**Morganza to the Gulf of Mexico Risk Reduction Project  
Biological Assessment (BA)  
Errata Sheet  
Updated March 21, 2013**

The Fish and Wildlife Service (Service) has prepared a Fish and Wildlife Coordination Act Report on the U.S. Army Corps of Engineers' (Corps) Mississippi River and Tributaries – Morganza to the Gulf of Mexico, Louisiana, Post-Authorization Change (PAC) report. That PAC report is being prepared to quantify costs and impacts of the Morganza, Louisiana, to the Gulf of Mexico Project (MTG) authorized under the 2007 Water Resources Development Act. That PAC report also examines the feasibility, costs, and impacts associated with two levee height alternatives, both of which are located on the alignment selected in the 2002 Feasibility Report. The PAC alternatives would protect against flooding from a 1 percent annual chance of occurrence storm (100-year frequency) and a 3 percent annual chance of occurrence storm (35-year frequency). The 100-yr frequency protection system has been chosen as the Tentatively Selected Plan. The PAC report will programmatically evaluate most project features; however, feasibility level evaluations are desired for the “constructable”

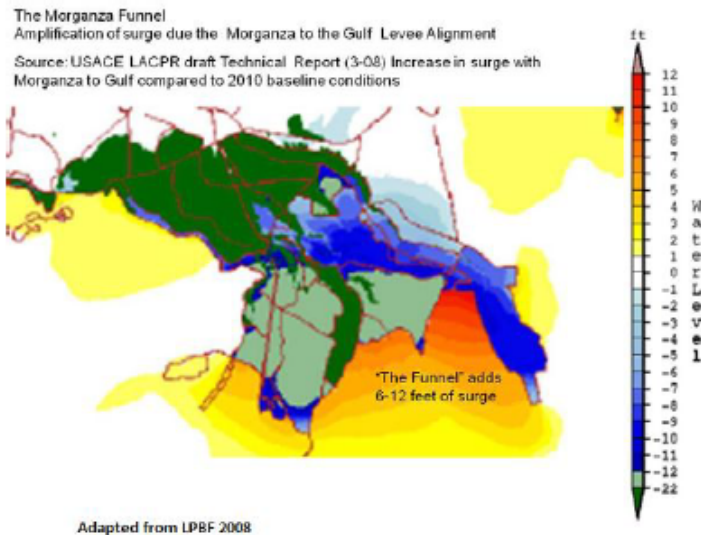
The segment crosses between ridges, across highly organic soils, which are likely "to have very poor geotechnical attributes for construction of a levee" (LPBF, 2008)<sup>11</sup>. Therefore, the Corps should not allow a levee to be built in this area. After the failure of hurricane levees post-Katrina, new soil standards for levees were adopted by the Corps. As this levee project is intended to encourage the Corps to build proper, higher levees along this alignment at a later date, Fill hauled in for this levee should be to the elevated standard.

The Project would create a funnel effect<sup>12</sup> that will require evaluation. This 'funnel effect' refers to levee alignments, which are not smooth but have angles between somewhat linear segments of the levee. To have a funnel effect, the angle needs to be open on the flood side of the levee.
